**Village of Arlington Heights, IL
Department of Building & Life Safety**

P.C. Number: 18-026 Round 2

Project Name: SUP for Gas Station

PLAN COMMISSION PC #18-026
7-11 Gas Station and Convenience Store
1650 W Algonquin Rd
SUP for Gas Station
Round 2

REMOVABLE HOOD basin and water
quality structure DETAIL

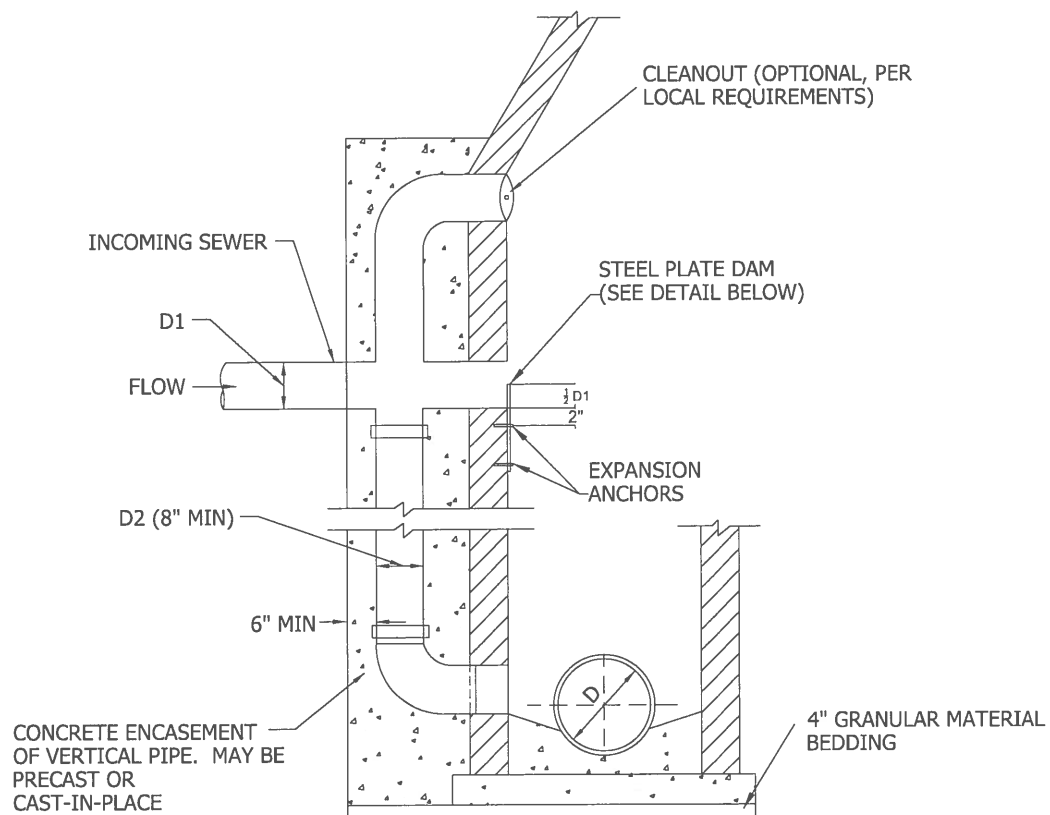
30. The petitioner's response to Comments #11, 12 and 13 is acceptable.
31. The petitioner's response to Comment #14 is noted. Regarding the snout oil-grit separator detail shown on sheet C-3 and the restrictor plate detail provided on sheet C-4, a removable hood should be constructed over the outlet pipe. For reference, enclosed is a removal hood detail from the Metropolitan Water Reclamation District (MWRD). If the restrictor is intended to be installed along with the snout oil grit separator, revise the detail accordingly and confirm that it meets the requirements shown in the MWRD detail. Provide the necessary details for the proposed detention storage system located under the pavement, and documentation that it is designed to meet the AASHTO HS-25 loading standard.

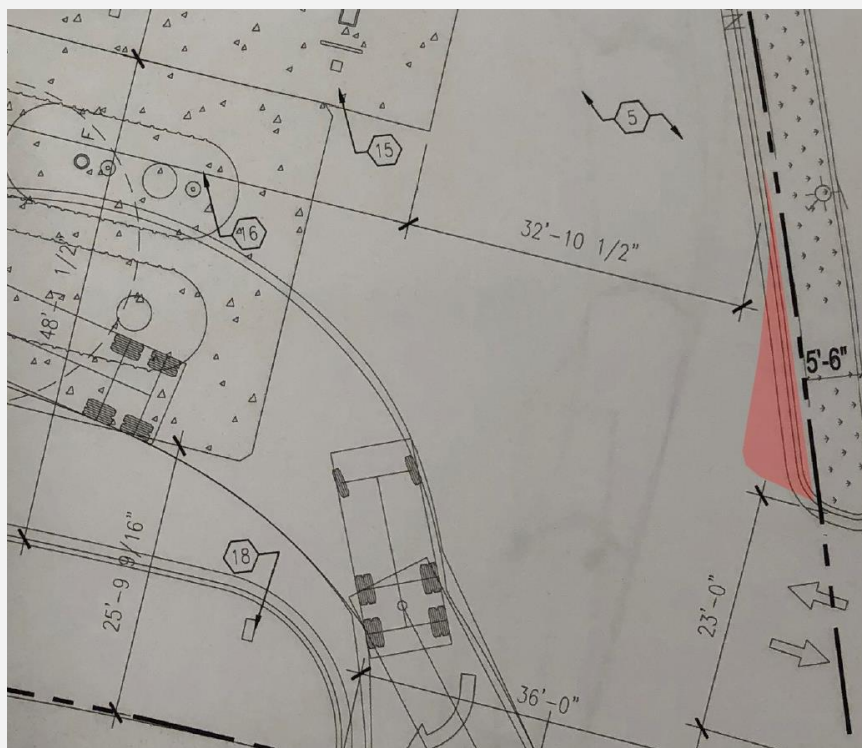
28. Your response to comment #19 is noted. A condition of approval will be recommended that will require revisions to the site plan to provide additional greenspace and landscaping by bumping out the curb as indicated below:
